ADDENDUM NO.: 01

ISSUED: June 24, 2024
to the Project Manual and Drawings for

CARTI El Dorado Cancer Center Phase 2
El Dorado, Arkansas
PSW Project No. 67IAG

-
- A. **GENERAL INFORMATION:** Addendum 01 contains revisions to Architectural drawings and MEP Specification Language as well a summary of Bidding question responses.

1 PHASE 2 - 1ST FLOOR NOTE PLAN
1/8" = 1'-0"

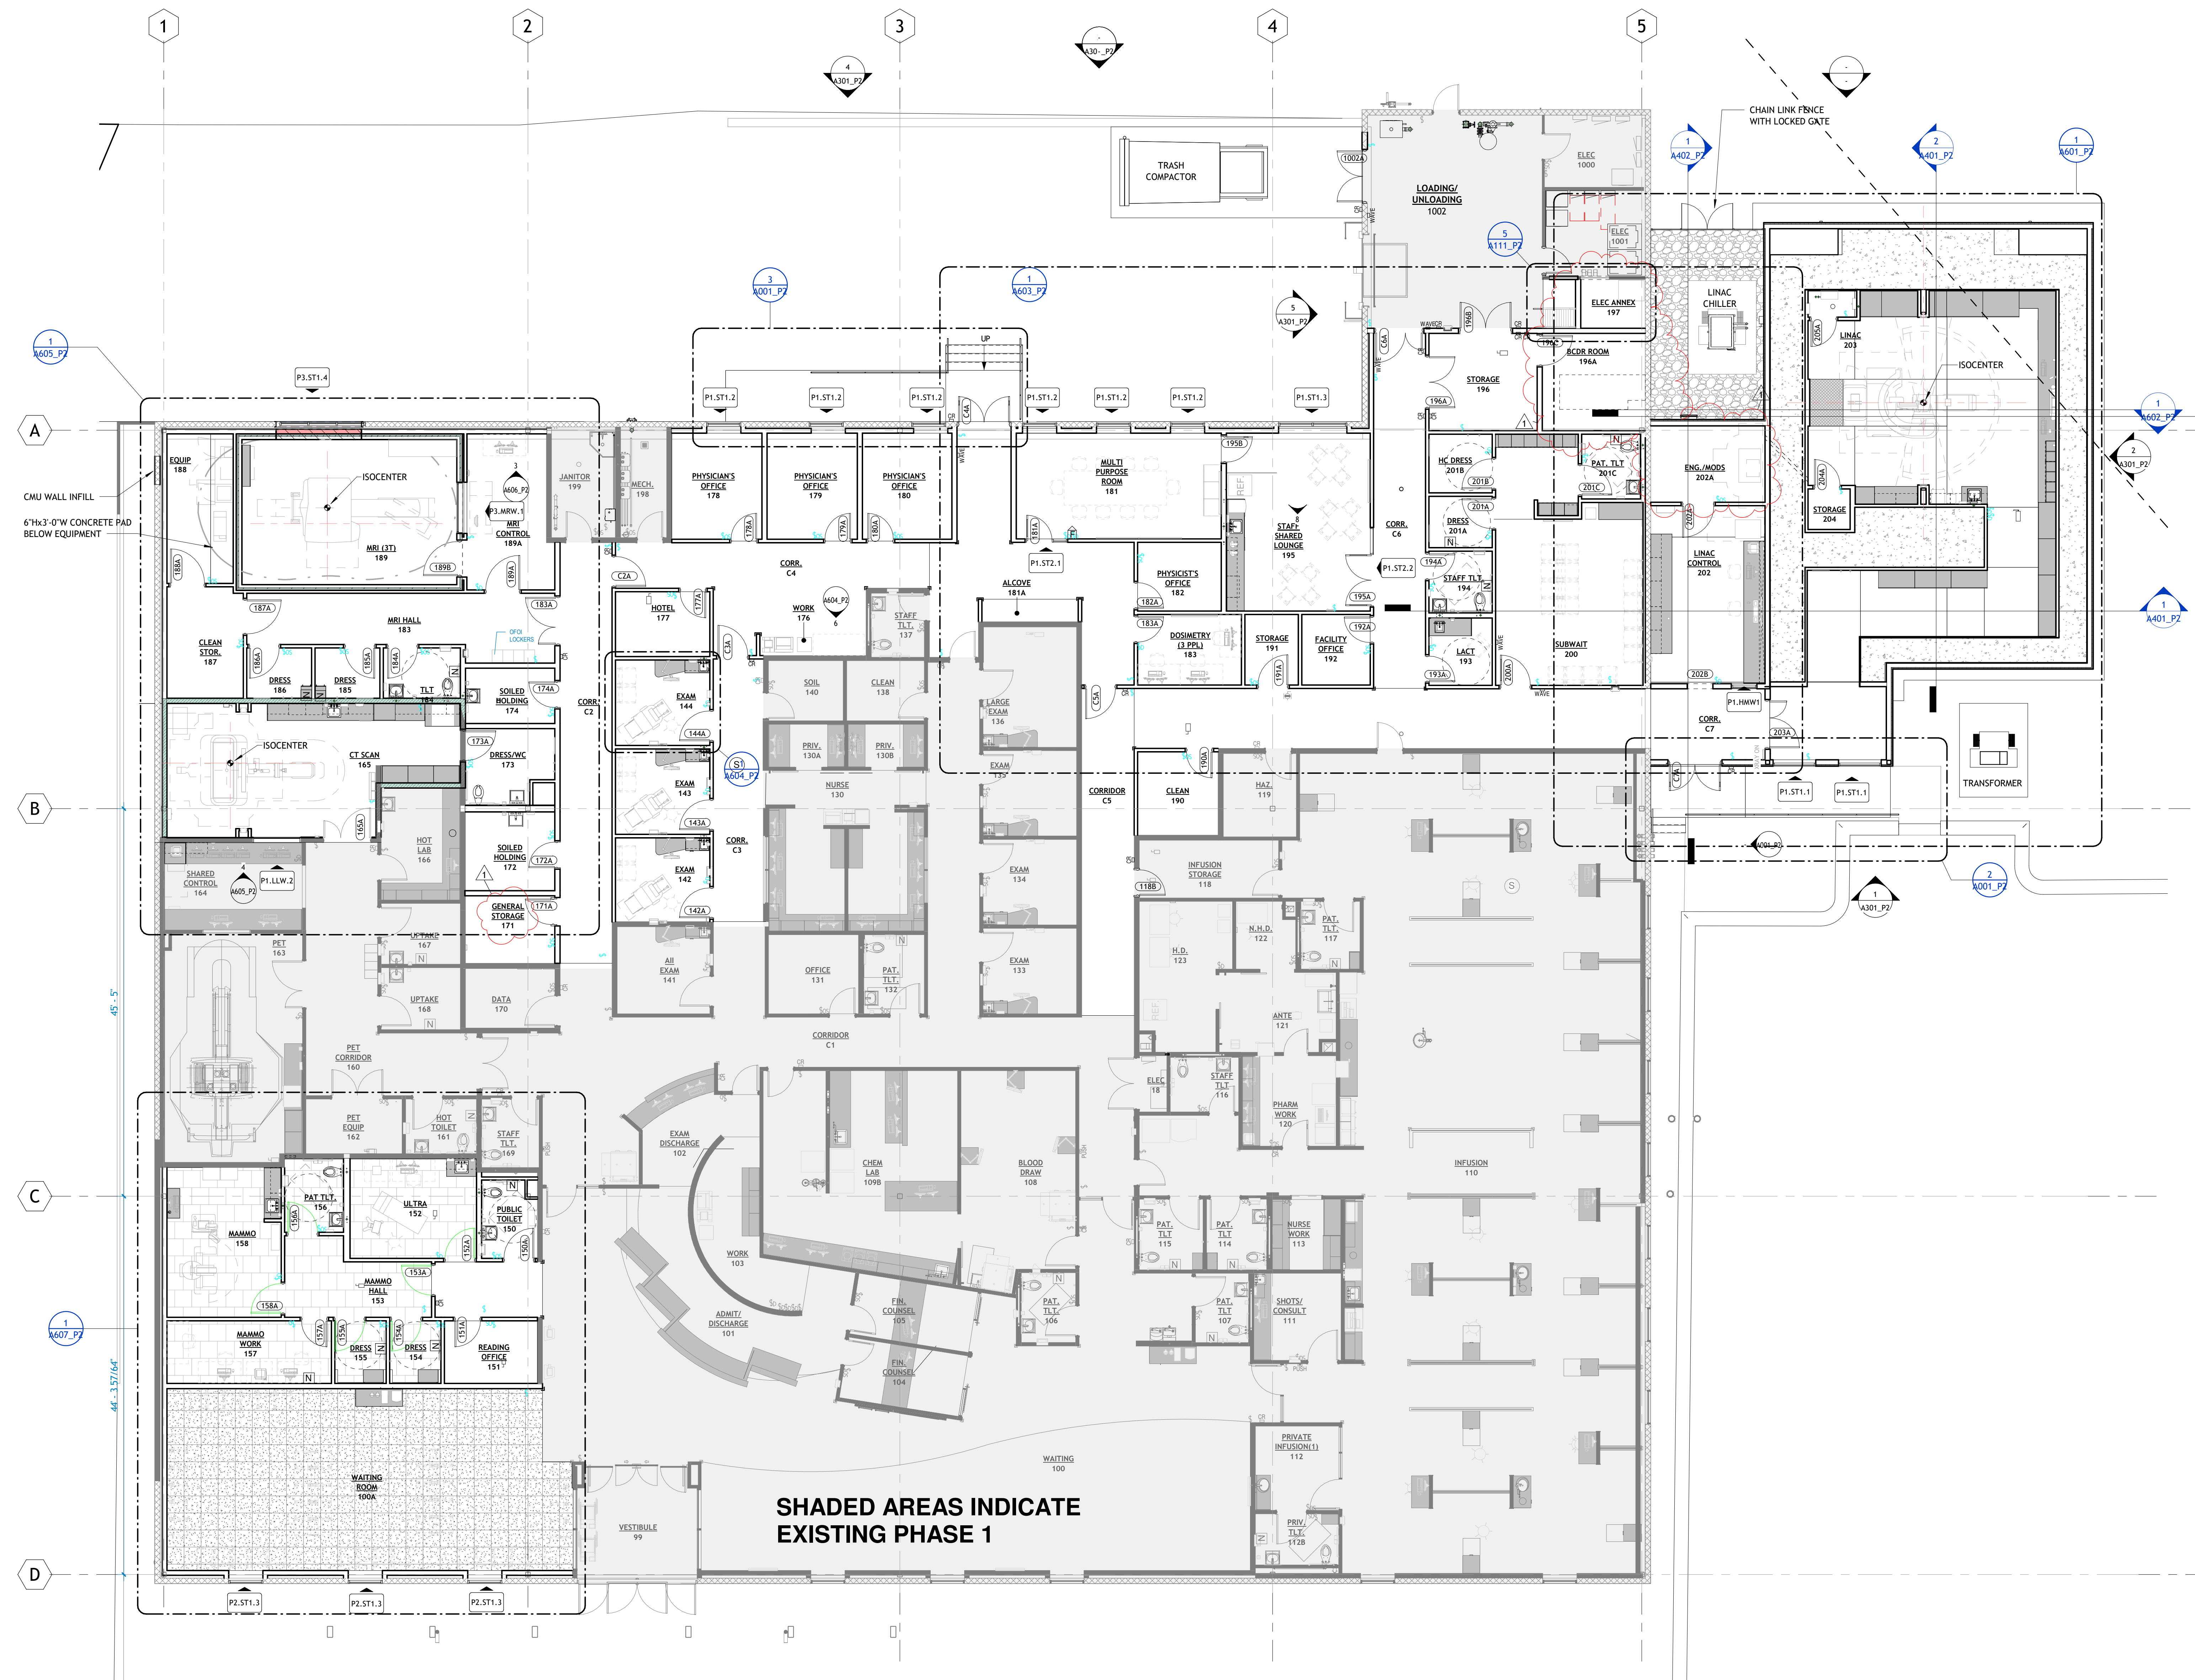
- ARCHITECTURAL:**
1. Refer to Revised Sheet **G002_P2- PH2_DRAWING INDEX**, revision dated 6.24.2024:
 - a. Revised DRAWING INDEX.
 2. Refer to Revised Sheet **A101_P2_PH2_FIRST FLOOR NOTE PLAN**, revision dated 6.24.2024:

- a. Revised LOCATION OF POWER CONDITIONER TO NEW ELEC ANNEX 197 & RECONFIG LOCATION OF LINEAR ACCELORATOR MODULATOR CABINET.
 - b. Revised LOCATION OF BCDR ROOM ADJACENT TO ELECTRICAL ROOM.

1 PHASE 2 - 1ST FLOOR DIMENSION PLAN
1/8" = 1'-0"

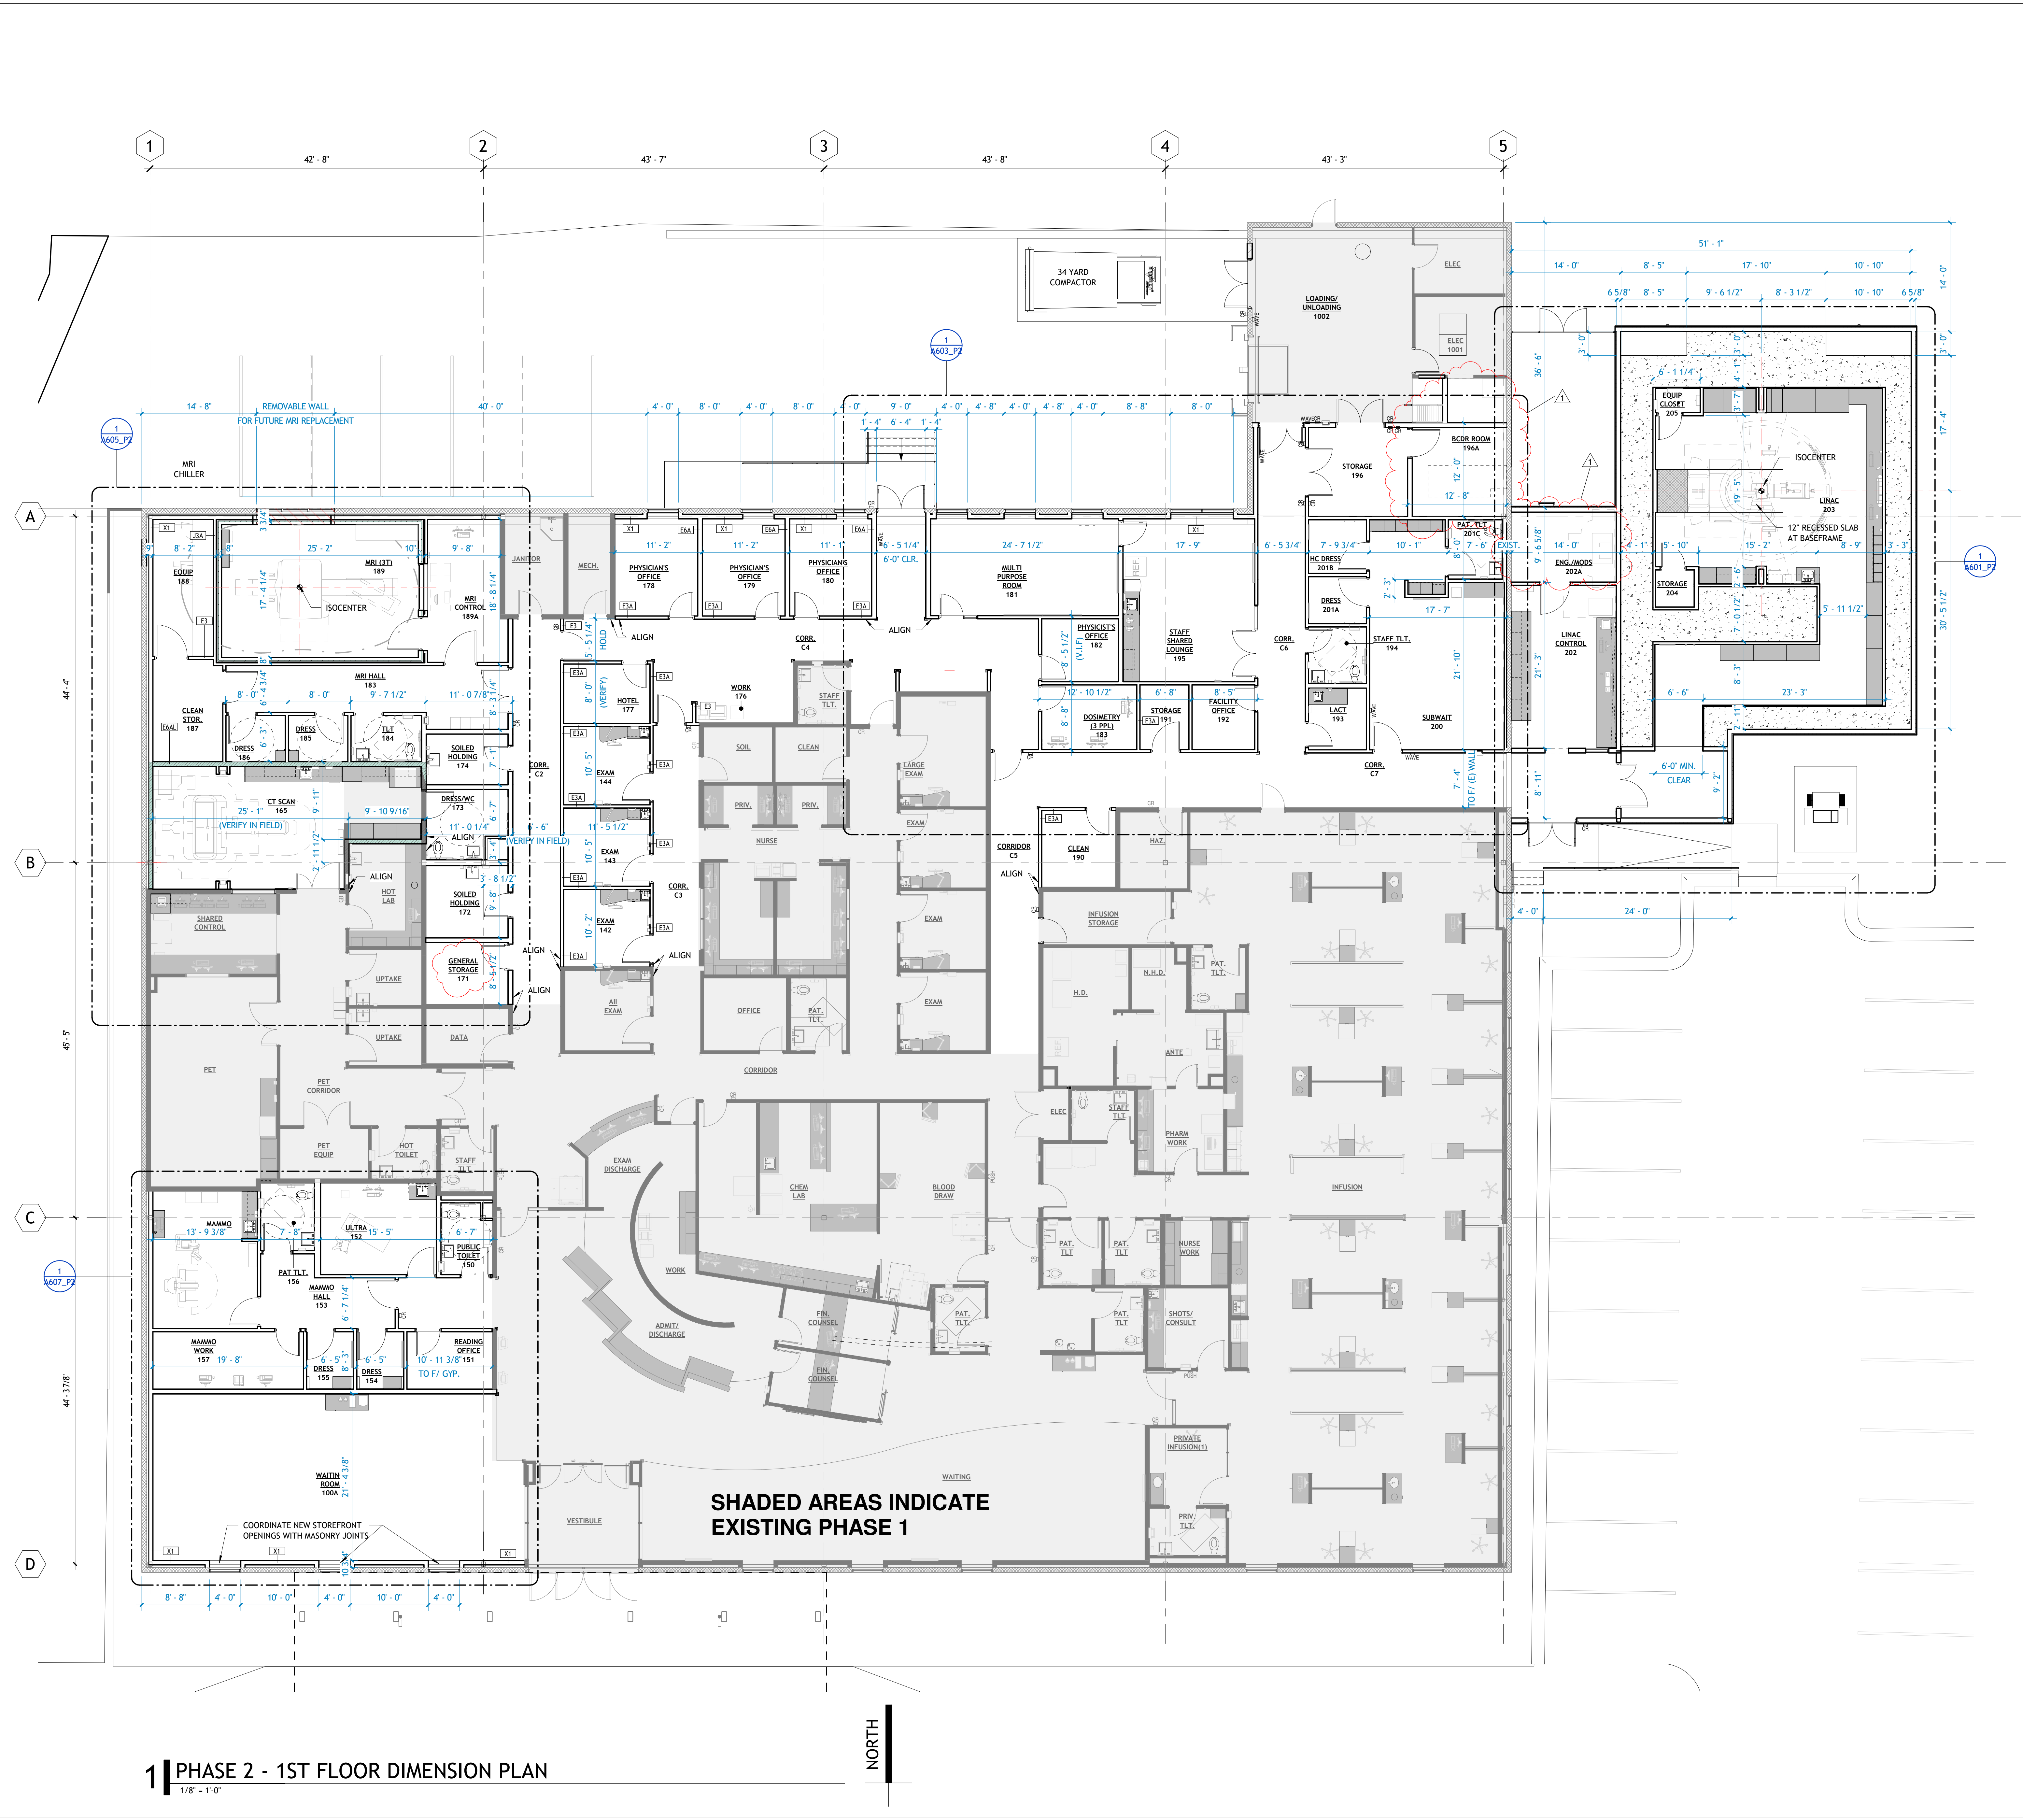
3. Refer to Revised Sheet **A102_P2_PH2_FIRST FLOOR DIMENSION PLAN**, revision dated 6.24.2024:
 - a. Revised LOCATION OF POWER CONDITIONER TO NEW ELEC ANNEX 197 & RECONFIG LOCATION OF LINEAR ACCELORATOR MODULATOR CABINET.

- b. Revised LOCATION OF BCDR ROOM ADJACENT TO ELECTRICAL ROOM.
 4. Refer to Revised Sheet **A201_P2_PH2_REFLECTED CEILING PLAN**, revision dated 6.24.2024:
